ADDENDUM

No. 03 Date: 9/11/2024
Project No. 0020711.01 Attention: Leonard D'Souza
Project Name: Princess Margaret Cancer Centre
Stem Cell Transplant 2, MHC, MHDU, DSC
Address: University Health Network
610 University Avenue
Toronto ON

This Addendum forms a part of the Bidding and Contract Documents and modifies the original issued Bidding Documents (dated August 13, 2024) for the above titled project, as indicated below, and is hereby incorporated into the Contract Documents as part thereof.

PT-302

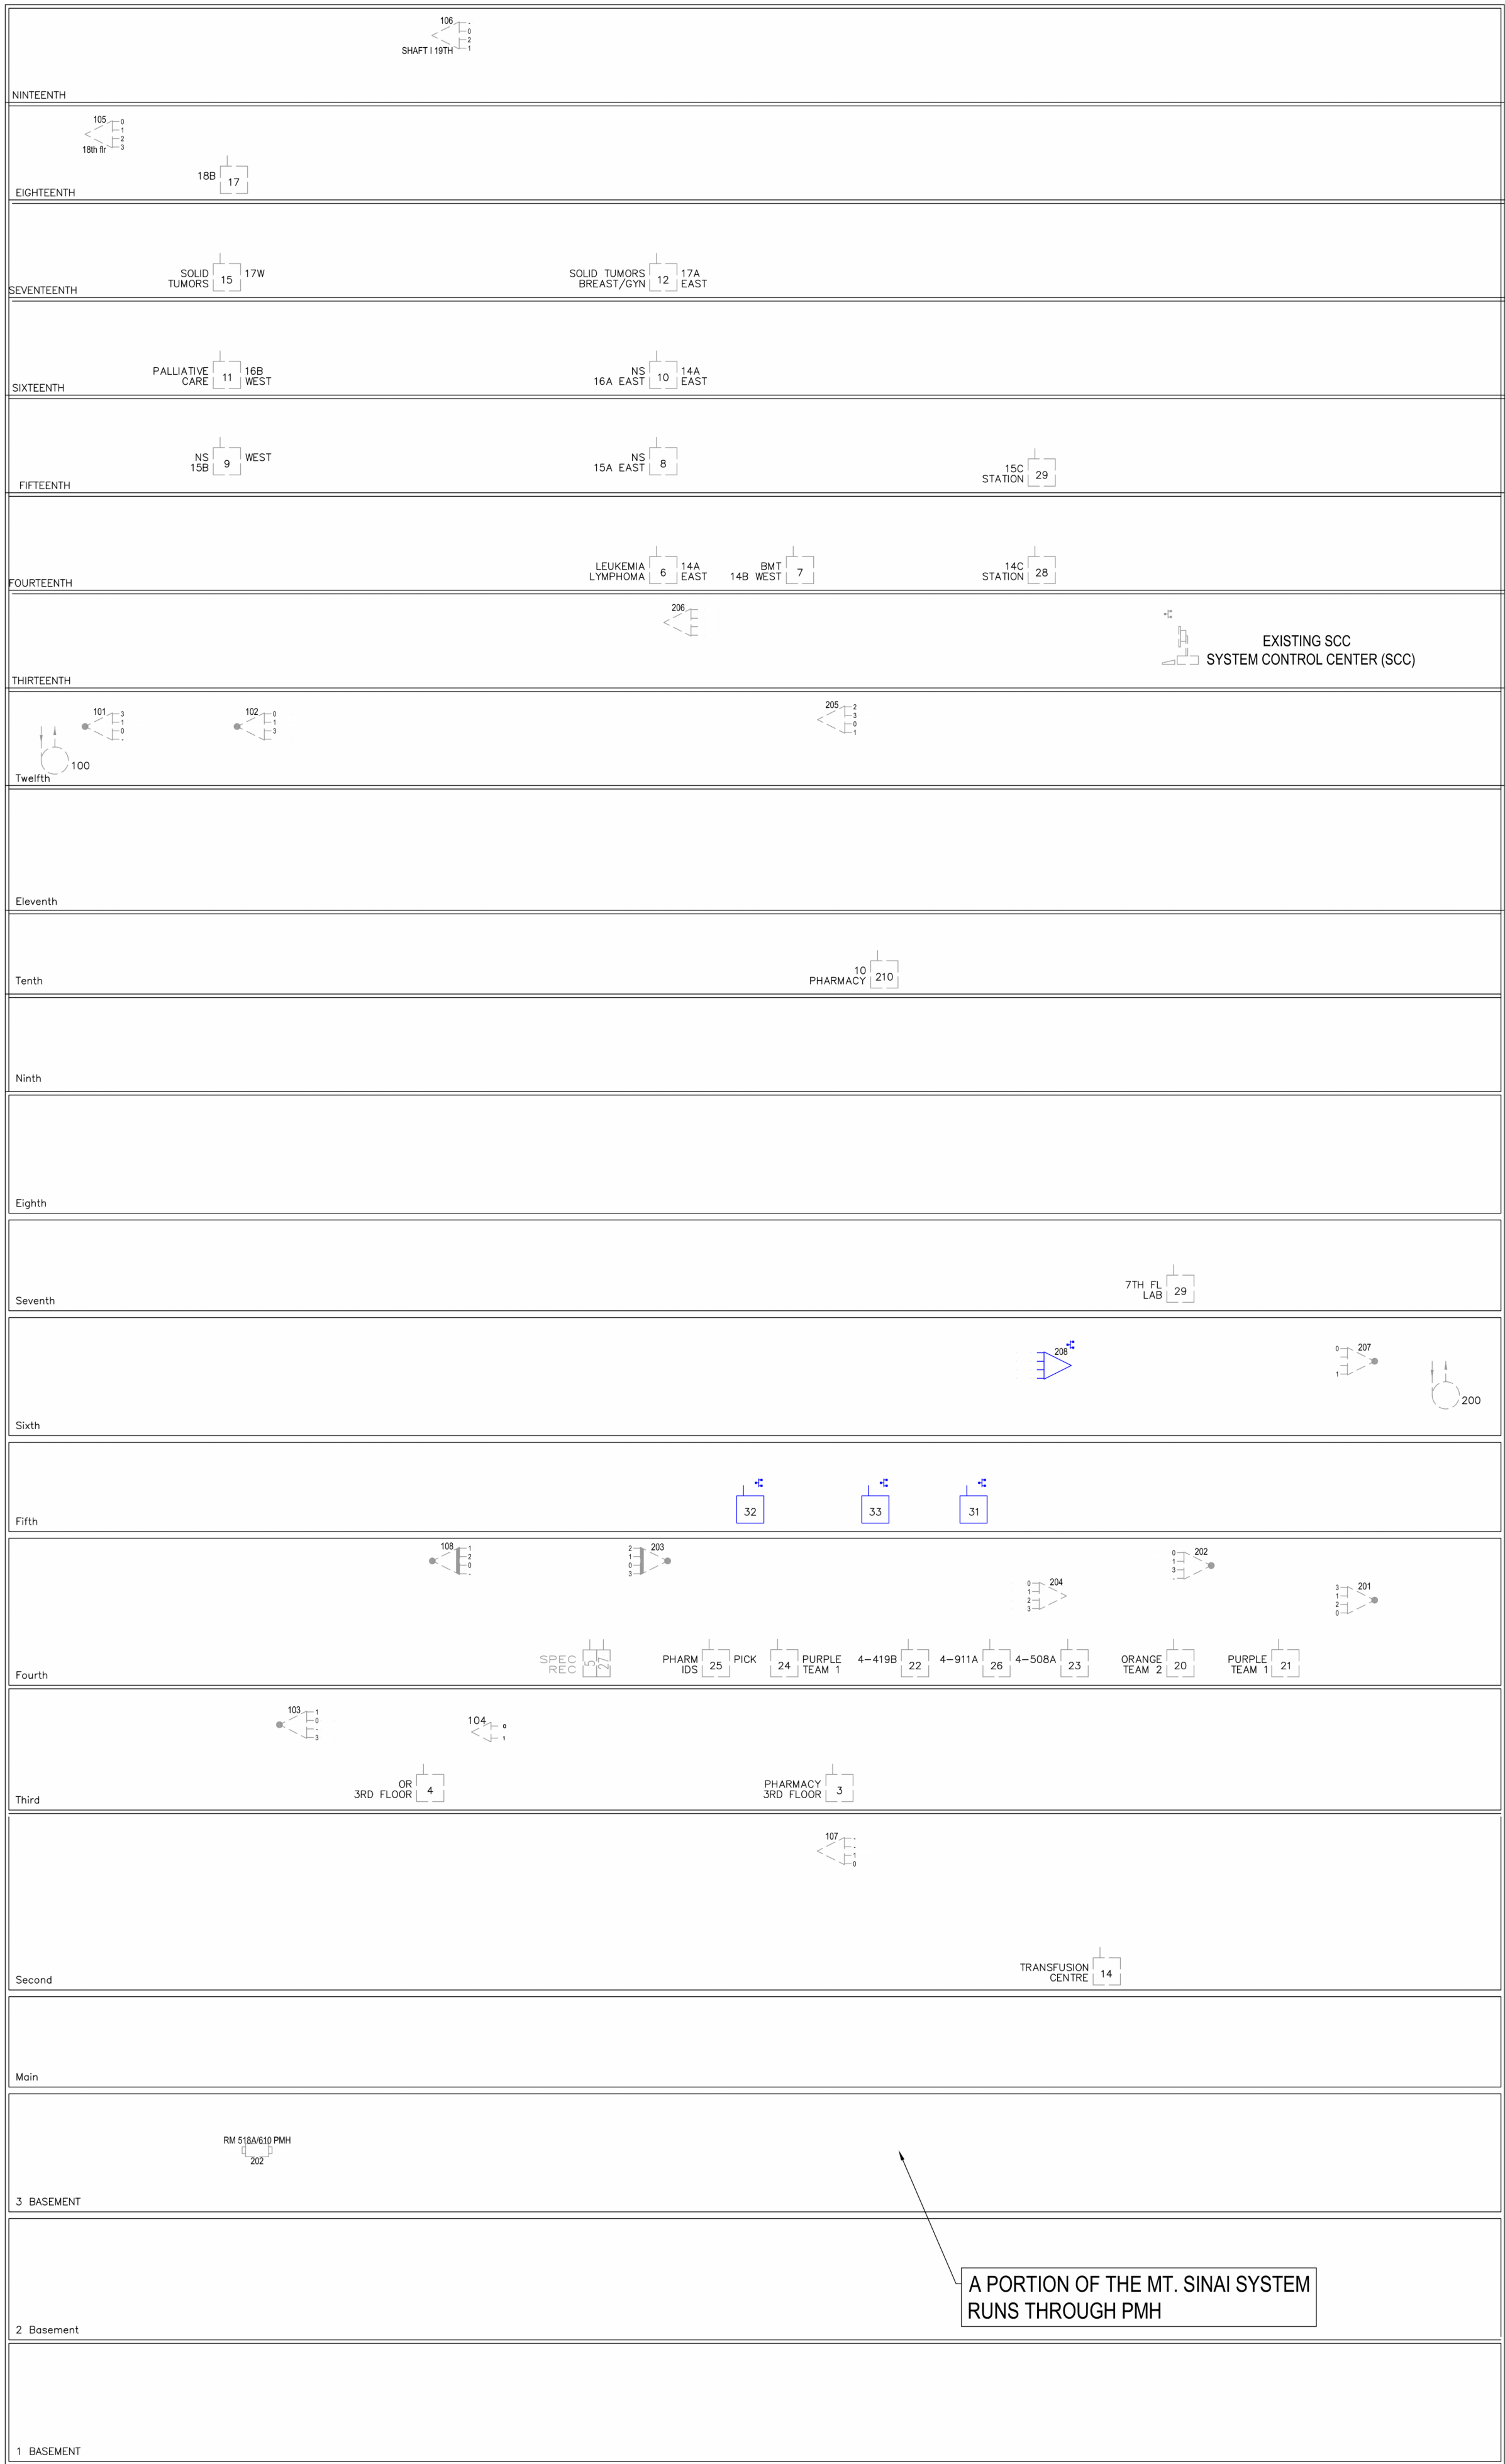
8. **Drawing PT-302 – PNEUMATIC TUBE SYSTEM – TRANSFER UNIT DETAILS**
 - Revision to details, as indicated.
 - Clarification of Mechanical Contractor's scope of work, as indicated.
